Authorization Letter

SUBJECT: Class II Permissive Change for FCC ID: N69-831000

The product, Traxit X 2G GPS Tracker, has been granted by FCC dated 07/14/2012, FCC ID: N69-831000.

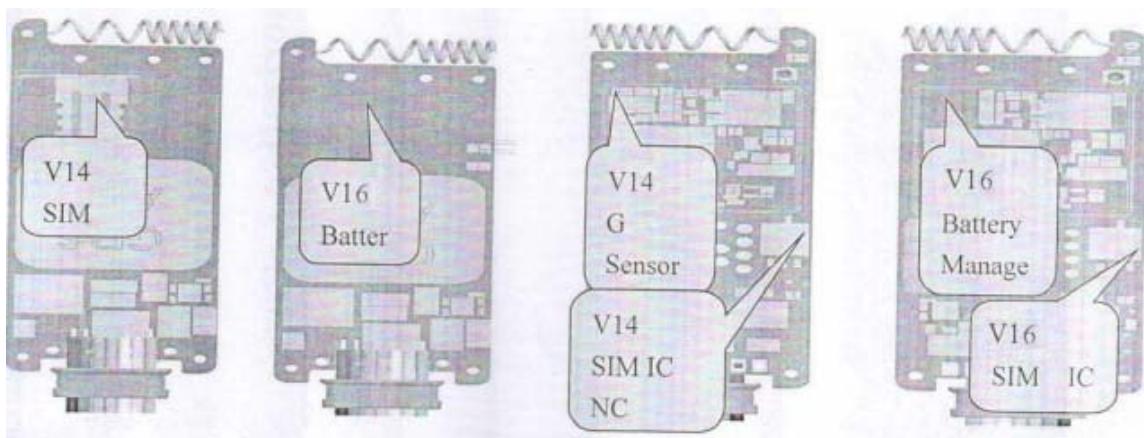
1. HW changed from IONX_V14 to IONX_V16

On PCB Board:

1) the position of Mounting SIM Socket in V14 be changed to Mounting Battery in V16.

2) Deleted some components of G-SENSOR in V14; and then added some components of battery manage in V16.

(3) It's null in the position of SIM IC in V14, but the SIM IC is mounted in the same position in V16.
